BELL BEND NUCLEAR POWER PLANT
PARTIAL RESPONSE TO REQUEST FOR ADDITIONAL
INFORMATION NO. 105, FSAR CHAPTER 3
BNP-2012-095
Docket No. 52-039

Response to NRC Request for Additional Information No. 105 Questions 03.02.01-1 and 03.02.01-3

Bell Bend Nuclear Power Plant

FSAR Figure 9.5-2 -- {Fire Water Distribution System - Site Specific Facilities}

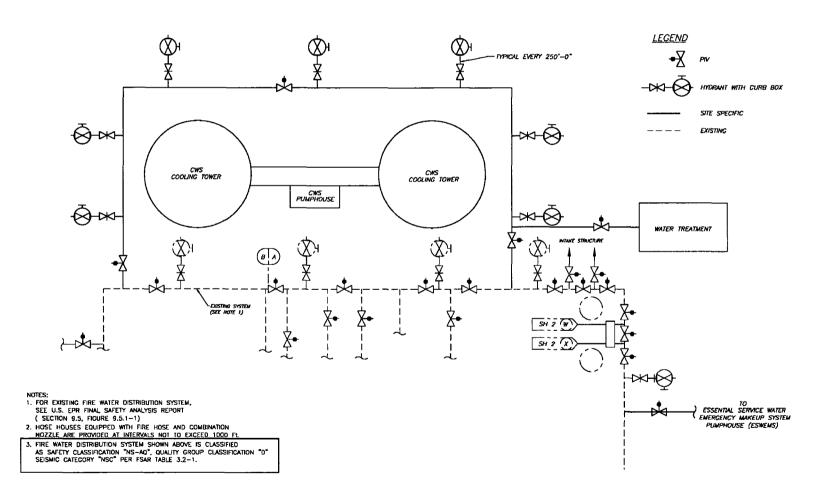
Site-specific SSCs for the fire water supply system and the fire suppression system were added to BBNPP FSAR Table 3.2-1. However, the BBNPP FSAR site-specific piping and instrumentation diagram (P&ID) Figure 9.5-2 "Fire Water Distribution System – Site Specific Facilities" does not identify the SSC's Seismic Category. Provide the SSC's Seismic Category on the simplified fire protection system P&ID Figure 9.5-2 in the FSAR.

The Fire Water Distribution System components shown on FSAR Figure 9.5-2 are assigned as Safety Classification "NS-AQ", Quality Group Classification "D", and Seismic Category "NSC", as described in FSAR Table 3.2-1. FSAR Figure 9.5-2 will be updated to provide a Note (Note 3) describing the safety, quality and seismic classification for the depicted Fire Water Distribution System components.

FSAR Figure 9.5-2 will be updated as shown to provide a description of safety, quality and seismic classification for the depicted Fire Water Distribution System components in a future COLA revision.
